10540 GREENWOOD AVE N
DESIGN REVIEW BOARD
2ND RECOMMENDATION MEETING
18th June 2018
DPD Project: #3022986

DESIGN REVIEW MEETING (SUPPLEMENTAL)

SDCI Project #: 3022986
 Address: 10540 Greenwood Ave. N
 Seattle, WA 98133
 Parcel #: 8911000340
 Project Type: Mixed-Use
 Project Description:

COMPARATIVE PERSPECTIVES

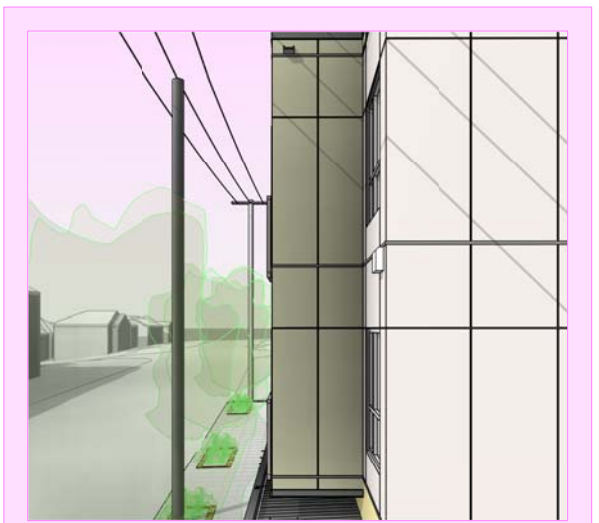
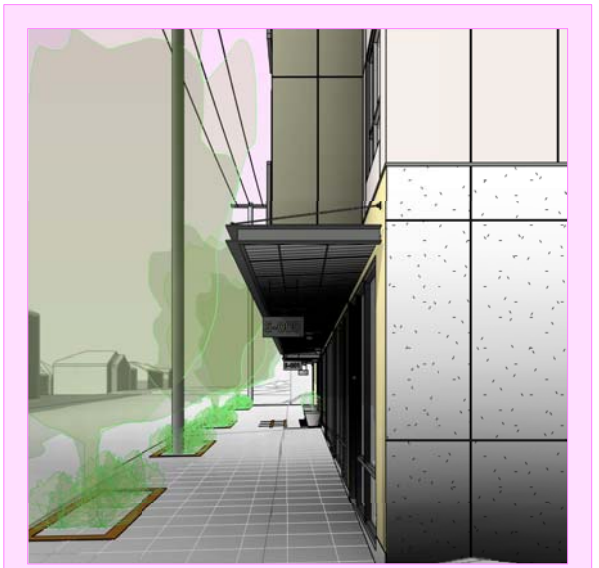
<p>2. Façade Composition</p> <p>a. West Elevation</p> <ul style="list-style-type: none"> i. The Board discussed the bays, commenting that the three southern bays created a regular rhythm however the differing width of the northern bay should be resolved. (DC2-B-1. Façade Composition). ii. In addition, the Board provided guidance to increase the height of the bays with the goal of further distinguishing the bays from the foreground massing and further strengthening the expression of the bays. (DC2-B-1. Façade Composition). iii. The Board was supportive of the channel along the east façade, however, they expressed some concern that aligning the channel and venting could be problematic at time of construction. The board provided guidance to further study this detail and confirm the constructability and location of this detail. (DC2-B-1. Façade Composition, PL2-C-2. Design Integration). iv. The Board expressed concern with the slight modulation along the 4th and 5th stories which accommodated the existing powerline without tying back to a design logic. The Board provided guidance to revise these floors to create a consistent setback along Greenwood Avenue. (DC2-B-1. Façade Composition). <p>b. North Elevation</p> <ul style="list-style-type: none"> i. The Board discussed the setback along the northern edge. At EDG the Board provided guidance to demonstrate the relationship of the proposed lightwell to the lightwell of the northern building. At Recommendation the board reiterated their direction to study this relationship and illustrate this adjacency condition at the next meeting. (DC2-B-1. Façade Composition). <p>c. South Elevation</p> <ul style="list-style-type: none"> i. The Board discussed the blank wall condition commenting that the large setback and channel recesses provided adequate relief along this part wall condition. (DC2-B-1. Façade Composition). <p>d. East Elevation</p> <ul style="list-style-type: none"> i. The Board supported the regular rhythm created by the bay expression which reduced the height, bulk, and scale along this zone transition. However, sections and a plan view study should be provided at the next meeting illustrating the relationship to adjacent neighbors, as well as, clarifying the depth of the rear open space and grade change. (DC2-B-1. Façade Composition, CS2-D-5. Respect for Adjacent Sites, CS2-D-4. Massing Choices). 	<p>Response:</p> <ul style="list-style-type: none"> a. <ul style="list-style-type: none"> i. All bays are now equal due to the eastern shift away from the mandatory high voltage clearance. (9, 11-13, 16, 29) ii. The bay height can't increase due to the power lines. In fact, they decreased in height slightly. (9, 16-19, 28) iii. The venting is located to either side of the channel with a false cover over the channel for visual effects. An exploded axonometric diagram has been added to convey this detail in the Elevations section. (16) iv. The top setback is now aligned along a single grid line, pursuant to the Board's guidance. (13, 16, 19, 28) b. <ul style="list-style-type: none"> i. The requested information has been included in the Neighbor Relations section. (20 21) c. <ul style="list-style-type: none"> i. The south elevation demonstrates the setback and channel recesses that provide adequate relief, as stated by the Board. (19) d. <ul style="list-style-type: none"> i. Sections and a plan have been added as requested. Additionally, an elevation of the fence as seen by the neighbors have been included. (18, 20 21, 28 29)

THE BRICK EXTENDS UP BETWEEN THE BAYS, ACCENTUATING THE DIFFERENCE IN RECESS FROM THE GROUND FLOOR AND 1st | 2nd STORY.

LEVEL 4 HAS A CONSISTENT SETBACK, MATCHES

BAY HEIGHT DIFFERENCE AND LOWER SETBACK.

BAY HEIGHT REDUCED (SEE PG. 9). SETBACKS,

MATERIAL, AND BRICK DISTINGUISH BAYS.

LEVEL 1 | 2 OFFSET CONNECTS LOWER | UPPER

LEVELS BRICK WRAPS CORNER FOR EMPHASIS.

ALL BAY WIDTHS EQUAL. LEVEL 1 ARTICULATION CLEANED UP; STEM WALL MIN. HT. IS 6", MULLIONS REPLICATE GARAGE DOOR.

STOREFRONT HT. DECREASES WITH SLOPE CREATING CONSISTENCY, AND CANOPIES DIVIDED BY CHANNELS.

▼ Looking Northwest at the East Fence. ▼

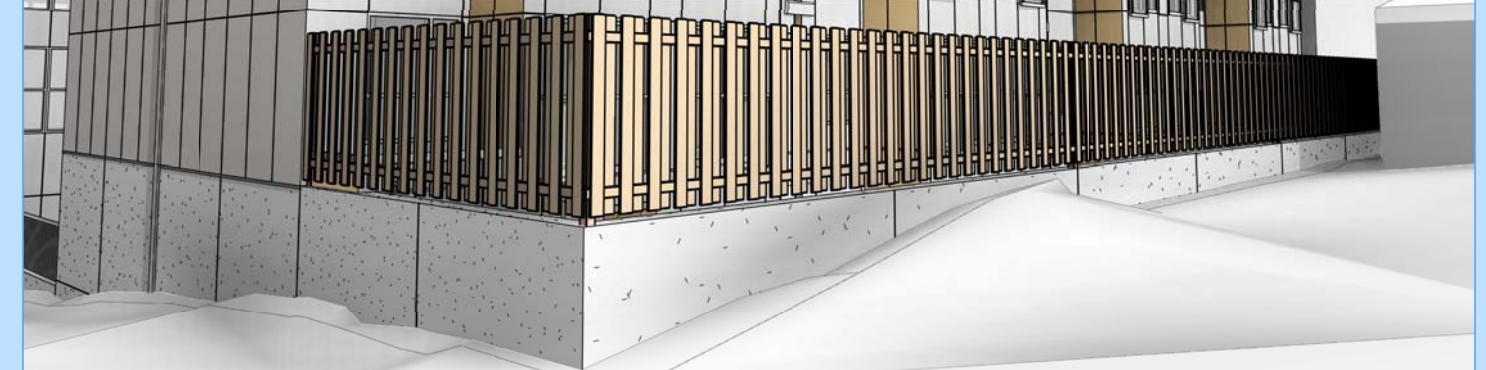
<p>5. Materials The Board discussed the proposed materials, supporting the proposed brick base and amount of transparency along the ground level. However, the Board was concerned with the large expanse of cementitious panel applied on the upper stories along Greenwood Avenue. (PL-B-3. Street-Level Transparency).</p> <p>a. The Board commented that the bays created an opportunity to break up this façade with a higher quality material and provided guidance to revise the bays accordingly. (DC4-A-1. Exterior Finish Materials).</p> <p>b. The Board further discussed the application of materials along the street-level, commenting on the need to clean up the articulation of the storefront bays with the goal of creating a more consistent expression. The Board provided guidance to revisit the stem wall, exploring a consistent base and additional mullions along the top of the storefront windows. (DC2-B-1. Façade Composition, DC2-D Scale and Texture).</p> <p>c. The Board discussed the application of brick commenting that the brick pattern needs to be further developed and provided guidance to explore the brick up below the windows between the bays or clarify the difference in recess from the ground floor and first/second story. (DC2-B-1. Façade Composition, DC2-D Scale and Texture).</p> <p>d. In addition, the Board discussed the horizontal fencing along the east edge and provided guidance to revise to a non-climbable fence. (DC3-C-2. Amenities/Features).</p>	<p>Response:</p> <p>a. Bay material has been changed to Western Red Cedar tongue and groove siding. (24)</p> <p>b. The storefront bays step down with the slope of the sidewalk, creating consistent vertical dimensions and canopy height, negating the guidance for additional mullions along the top. Mullions have been dimensioned to mimic the dimensions of the glass garage panels and the stem wall has been redeveloped to create a 6 inch minimum height at each canopy height change. (11, 16, 24, 29)</p> <p>c. The brick wall is no longer flush with the residential wall above, the height between the bays have been increased. The first level channels have been changed to gray to distinguish the first and second level changes. (24, 29)</p> <p>d. The standard horizontal wood fence has been changed to a vertical wood fence with a 1.5" gap and alternating picket placement to allow greater light penetration. (18, 24, 30)</p>

FENCING VERTICAL TO REDUCE CLIMBABILITY. THE 1 1/2" GAP BETWEEN PICKETS AND ALTERNATING ATTACHMENT TO

THE HORIZONTAL BEAMS ALLOW GREATER LIGHT PENETRATION.
